**Ojai Basin Groundwater Management Agency  
Meeting  
July 28, 2022  
3:00 pm**

# Addendum 1: Detailed responses to the SWRCB July 1, 2022 Comment Letter

# Addendum: Detailed responses to the Non-Governmental Organization Consortium April 30, 2022 Comment Letter

FIGURE 1

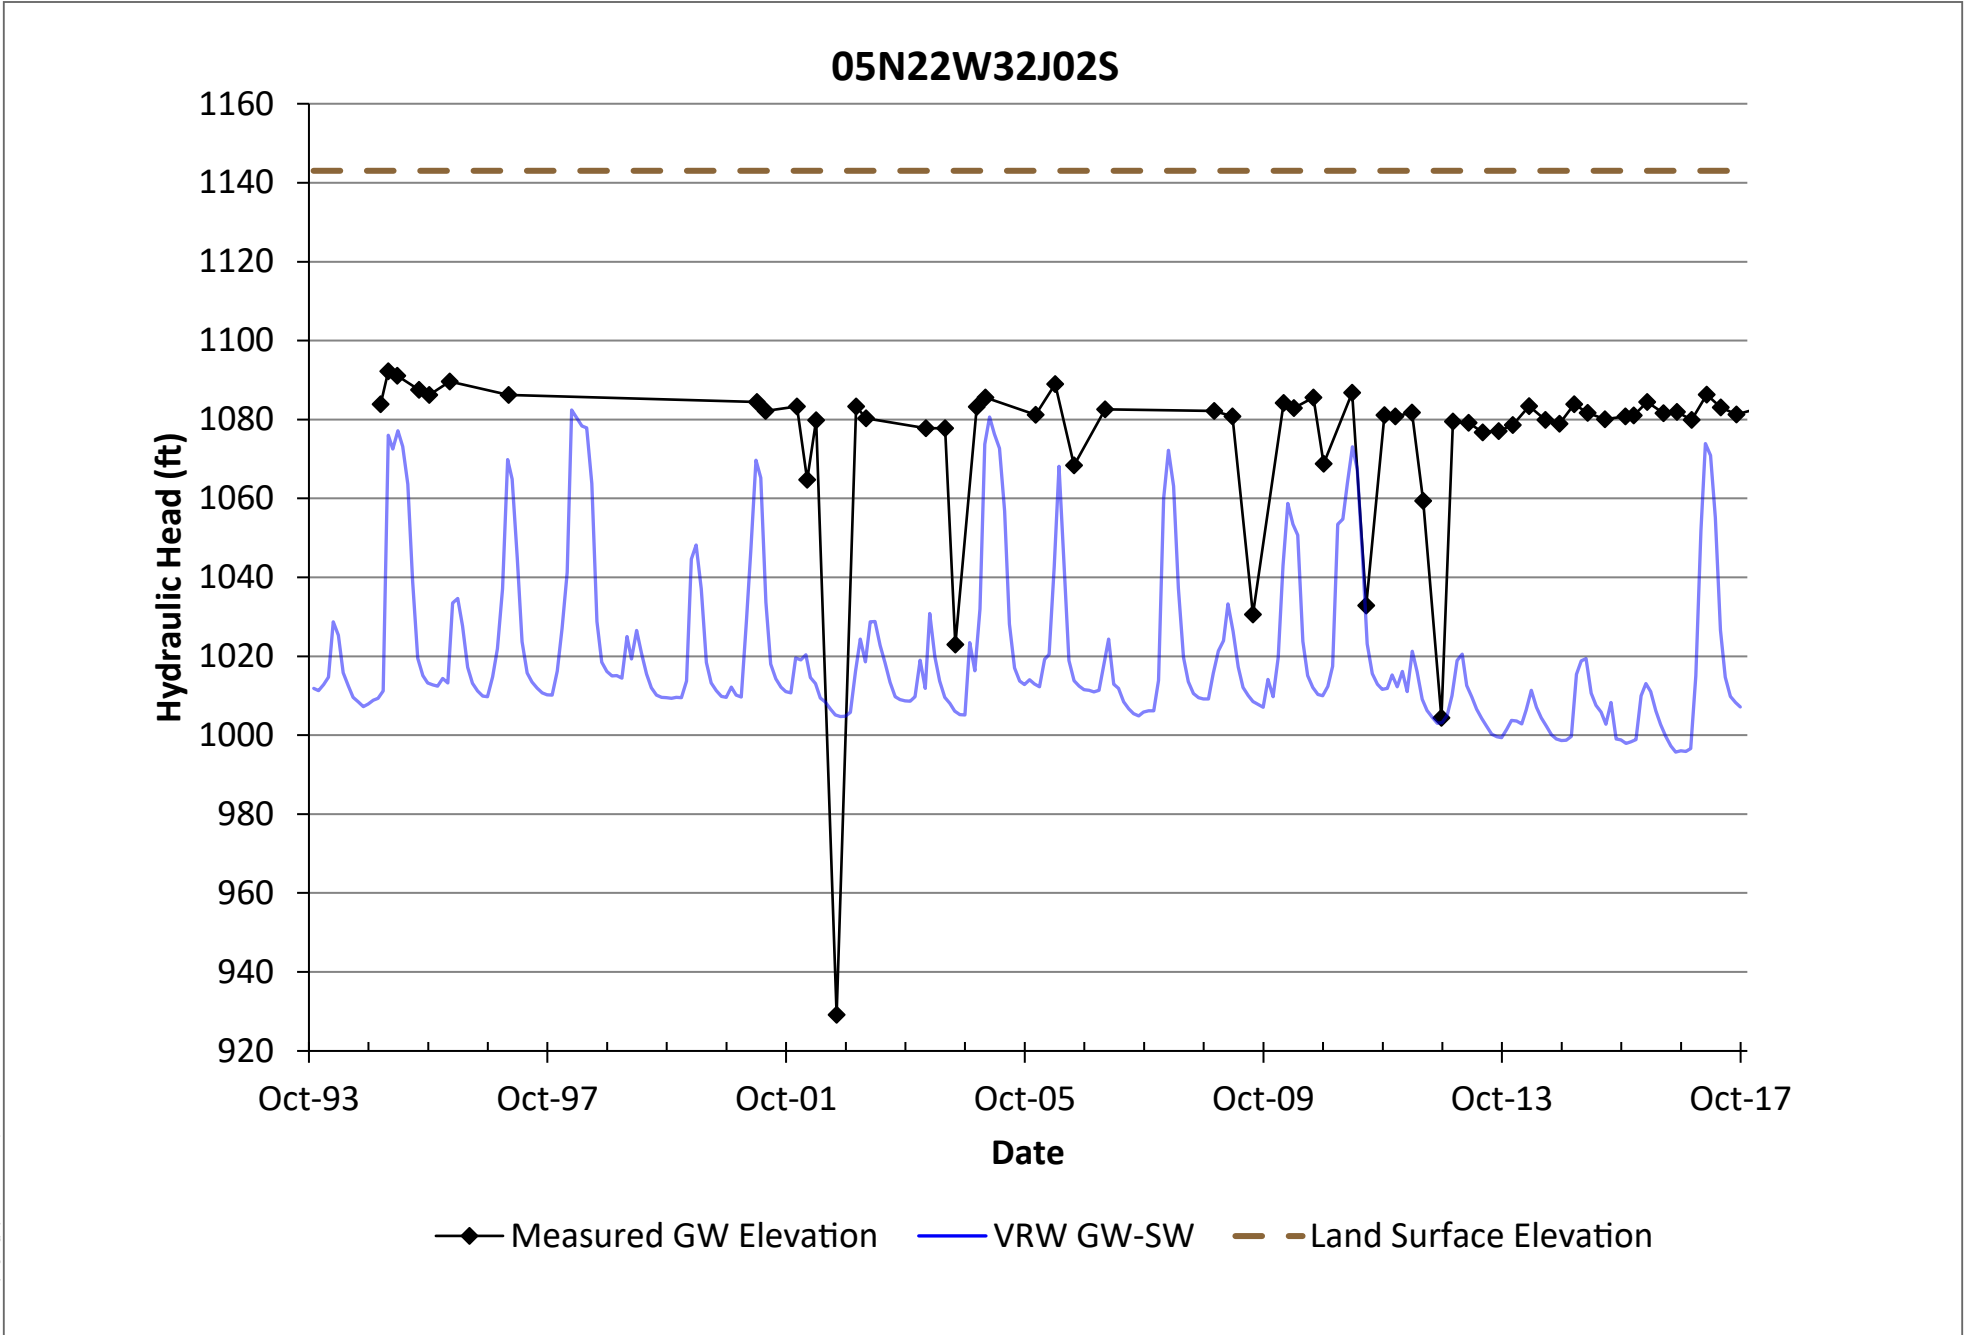
In the central and western OVGB, the model does a good job of reproducing historical groundwater elevation trends near San Antonio Creek (e.g., at wells 04N22W05D03S and 04N22W06K03S; Figures 1, 4, and 5). However, at well 04N22W06K03S, the VRW GW-SW model overestimates the frequency with which groundwater actively contributes to stream flow in San Antonio Creek. Over the simulation period, the model estimates groundwater elevations were greater than the land surface elevation during five discrete time intervals (Figure 5). In contrast, measured groundwater elevations at well 04N22W06K03S did not exceed the land surface elevation at any time between October 1993 and September 2017 (Figure 5). Furthermore, during the recent drought, the VRW GW-SW model underestimates groundwater elevation declines at 04N22W06K03S by approximately 80 to 140 feet and predicts a more rapid and pronounced groundwater elevation recovery than observed in the measured data (Figure 5). Similar discrepancies between modeled and measured groundwater elevations occur at well 04N22W07B02S (Figures 1 and 6).

Within the estimated extent of the perched aquifer as shown on Figure 1, the VRW GW-SW model generally overestimates groundwater elevation fluctuations and responses to

FIGURE 7

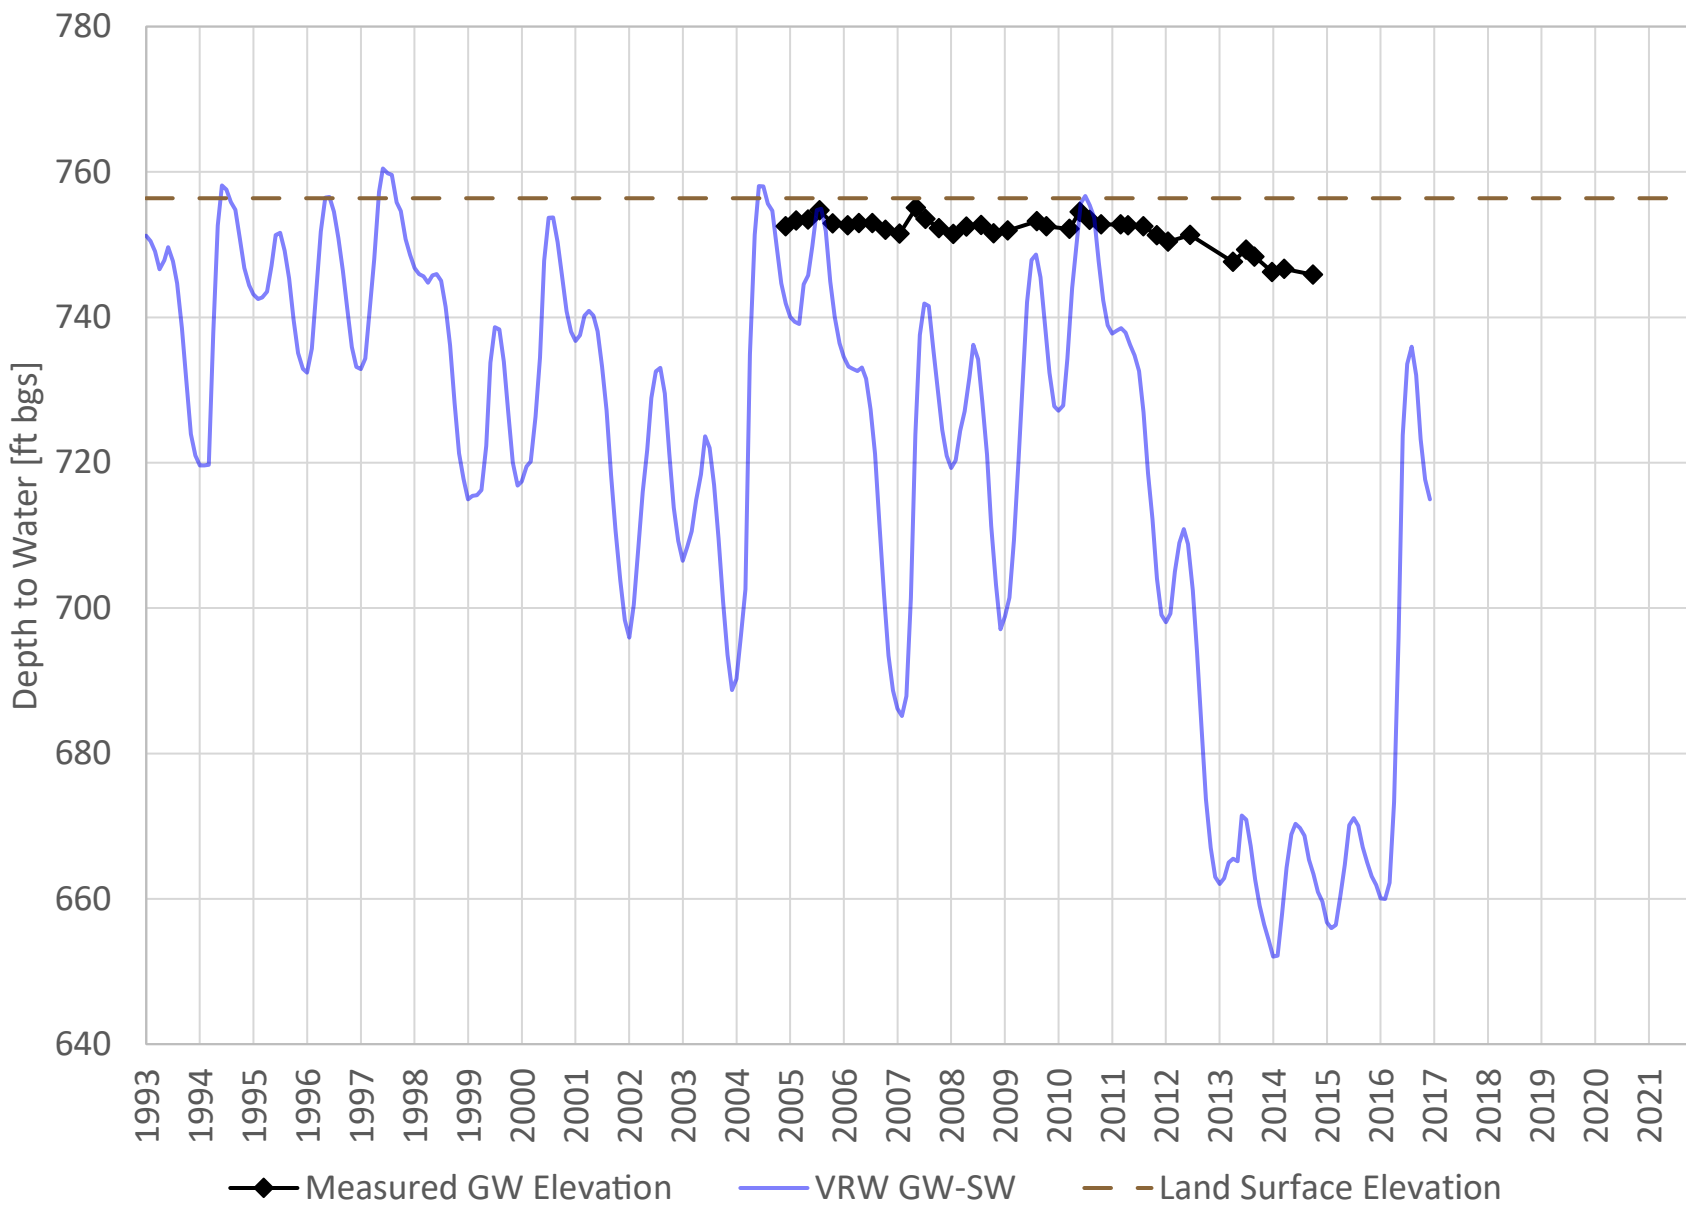
climate. Groundwater elevations have been measured in the shallow perched aquifer since 2005 at the Ojai Valley Imports MW-1 well<sup>2</sup> (Figures 1 and 7). At this well, where groundwater was encountered at an average depth of approximately 3.5 feet below ground surface (bgs), groundwater elevations remained relatively stable from 2005 to 2011 and exhibited seasonal variations of up to 4 feet (Figure 7). During this same period, the VRW GW-SW model predicts that groundwater occurs at an average depth of approximately 25 feet bgs and that seasonal groundwater elevation declines exceed 70 feet during dry climatic periods, which is in stark contrast to the stable groundwater elevations measured at this well (Figure 7). During the peak of the 2011–2015 drought, the VRW GW-SW model simulates groundwater elevation declines of approximately 100 feet at this well; conversely, groundwater elevations measured at the Ojai Valley Imports MW-1 declined by approximately 10 feet during this period (Figure 7).

FIGURE 8

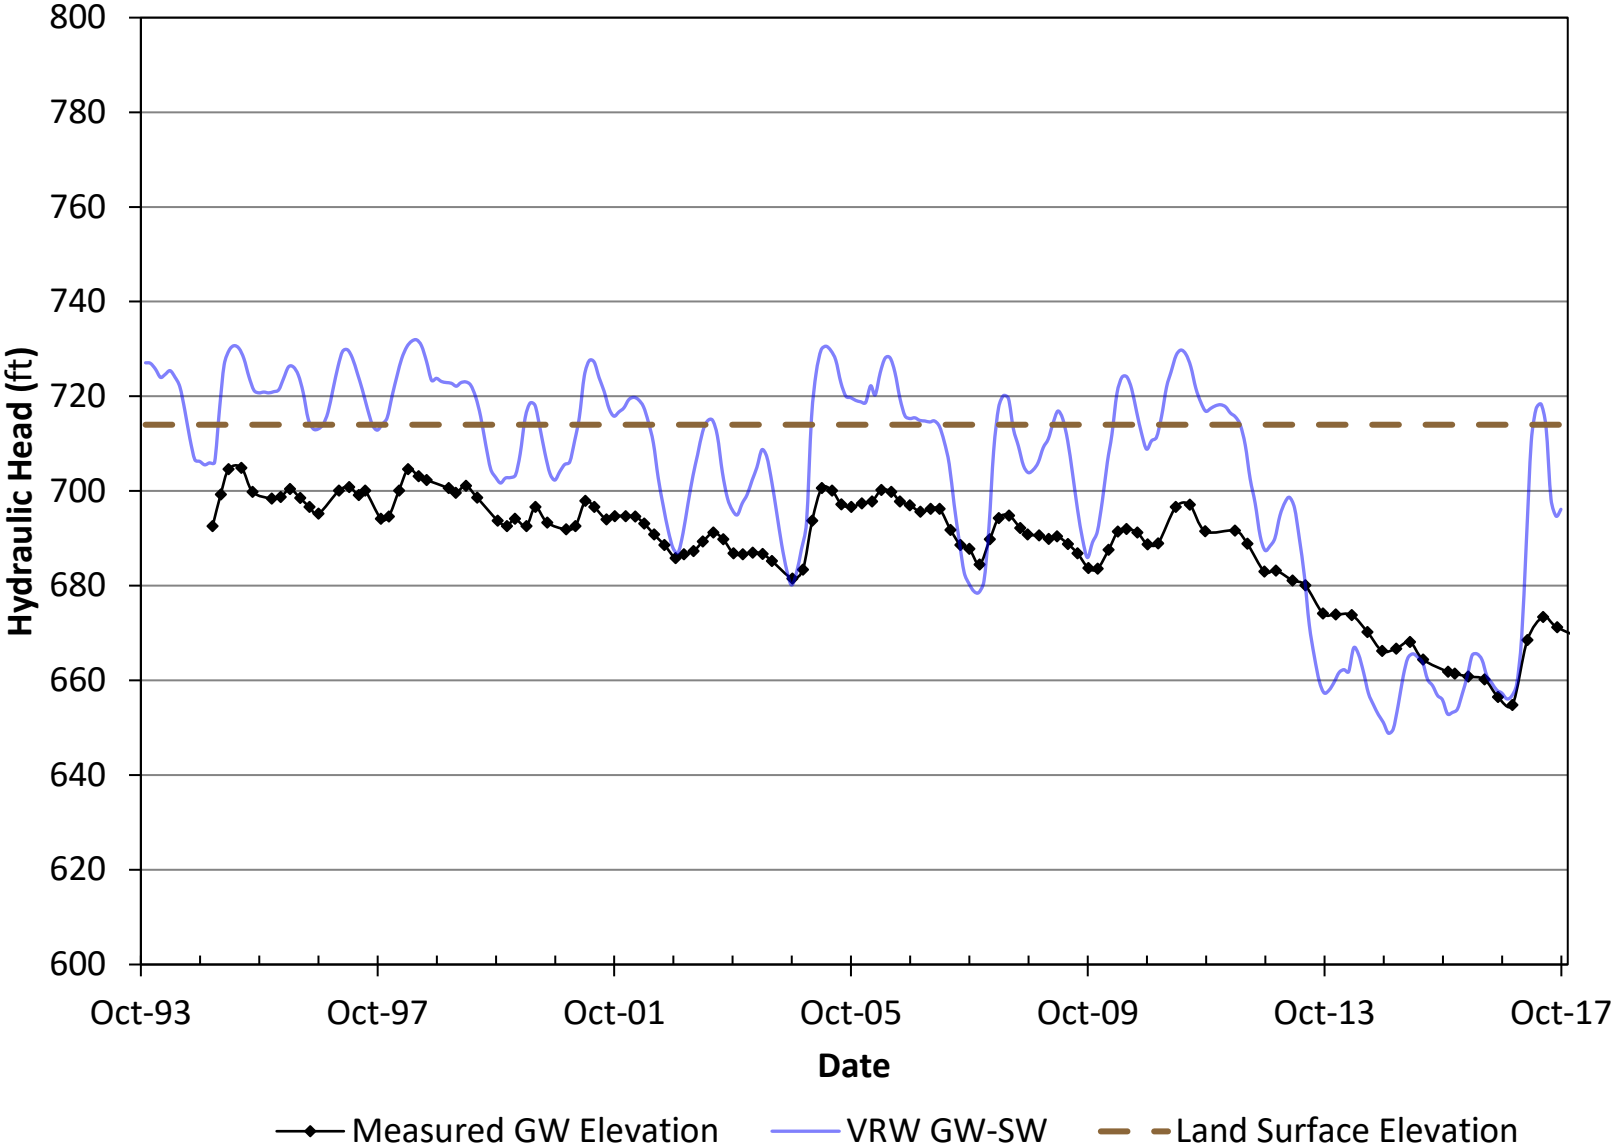
In the southwestern portion of the OVGB, along the downstream reaches of San Antonio Creek, the VRW GW-SW model does a reasonable job representing the long-term declining groundwater elevation trend measured at well 04N23W12H02S (Figures 1 and 8), but over-estimates the seasonal groundwater elevation variability measured at this well (Figure 8). This results in modeled conditions in which groundwater contributes to baseflow at this location of San Antonio Creek (e.g., groundwater elevation is higher than land surface elevation; Figure 8). Groundwater elevations measured at 04N23W12H02S indicate that groundwater has occurred at approximately 15 to 50 feet bgs since the mid-1990s (Figure 8). A comparison of simulated groundwater levels to simulated stream flow at gage 605/605A demonstrates that the seasonal variability in simulated groundwater elevations at this well are correlated to stream flow events (Figure 9); the dampened response in the measured groundwater elevations at this well indicates that the VRW GW-SW model overestimates the degree of connectivity between surface water and groundwater in this part of the perched aquifer. The VRW GW-SW model simulates similar responses to stream flows in deeper portions of the aquifer (e.g., as measured at well 04N23W12L002S; Figures 1 and 10). Importantly, at well 04N23W12L002S, the VRW GW-SW overestimates groundwater elevations, which likely results in an overestimate of the volume and rate of groundwater discharges to San Antonio creek in this part of the OVGB.
